70-734

SUBJECT: Docket No. 70-734; License No. SNM-696; Submittal of Updated Pages  
to License Specifications

Fig. II 3.1-1 Radioactive Materials Management Organization Chart

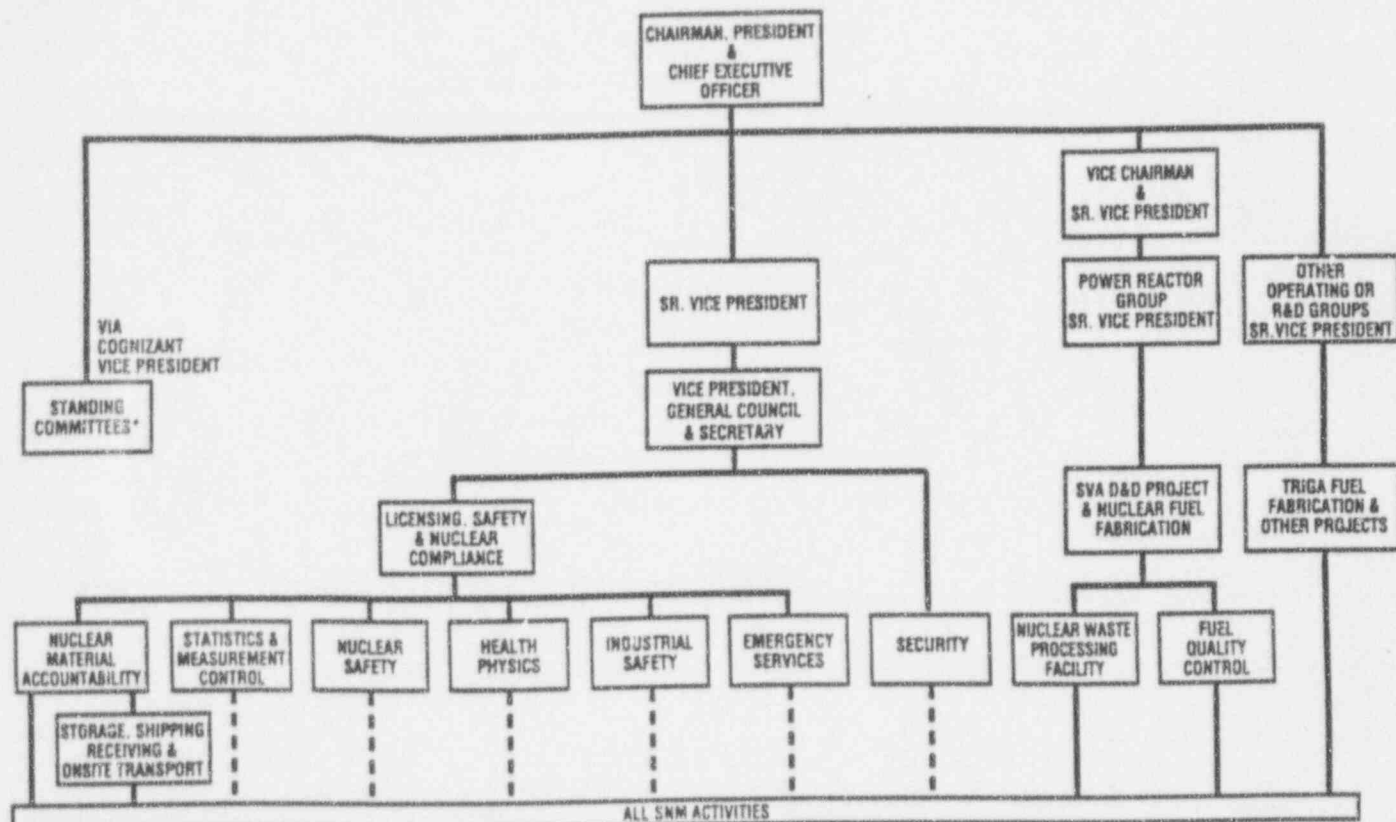
Until his retirement, all functions responsible for assuring General Atomics' (GA's) compliance with license requirements and applicable regulations reported to Mr. Rademacher, GA's Vice President of Human Resources. Now, all of those same functions report to Mr. James R. Edwards, Vice President, General Counsel and Secretary. Just as Mr. Rademacher did, Mr. Edwards reports to Mr. Ed Jones, Senior Vice President. Various members of NRC staff at Headquarters and Region V (now IV) were advised of this change in personnel shortly after it occurred. The purpose of this letter is to submit an updated Section 3 of GA's License Specifications which reflects this change.

The revisions consist of removing all references to the Director (later Vice President) of Human Resources and replacing them with Vice President, Legal (where it is first explained that Vice President, General Counsel and Secretary will be referred to simply as Vice President, Legal). Additionally, references to the "Manager" of Licensing, Safety and Nuclear Compliance (LSNC) have been replaced with "Director." While not every page required revising, for convenience in updating your records, a new Section 3 in its entirety is being provided dated July 1994.

The Vice President, Legal, or his designee, will establish the necessary policies of operation, cause them to be published in company-wide guides and manuals, and coordinate related activities with operating groups to assure compliance with related policies, procedures, regulations and license conditions. The Vice President, Legal reports to a Senior Vice President (see Fig. II 3.1-1).
